Controller, Programmer, and Mounting Hardware - Power Tiger

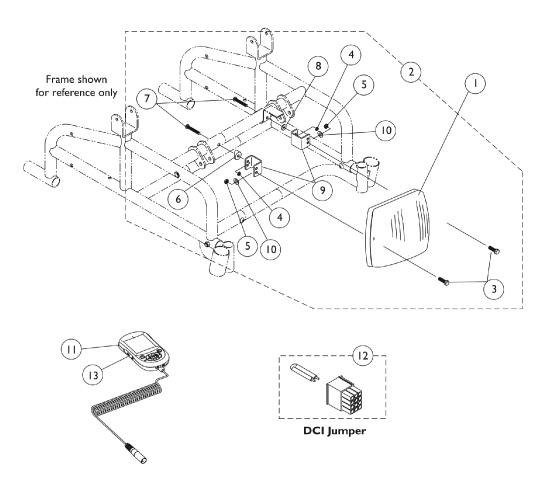
B - After 10/8/06 the MK5 NX w/ ACC controller was revised to function as a MK660 w/ ACC or MK5 NX w/ ACC controller. The part # did not change and the label was revised to only show MK660 w/ ACC.

B1 - Revised controller is backward compatible with MK5 Driver Controls manufactured Before 10/9/06. Controllers in the field that show the MK5 NX w/ ACC label and serial # dated Before 10/9/06 will not have revised software to work with MK6i Driver Controls.

D - Part #1148361 controller is no longer required as a replacement for a chair ordered with Manual Tilt Option before 1/19/07.

D1 - because the software for part #1127270 was revised 8/31/07 to version 2.61a and now accommodates all Manual Tilt optioned chairs shipped before 1/19/07 as well.

E - Used for Chairs with Manual Tilt Option only. Discontinued 8/31/07, see part #1127270 as a direct replacement.
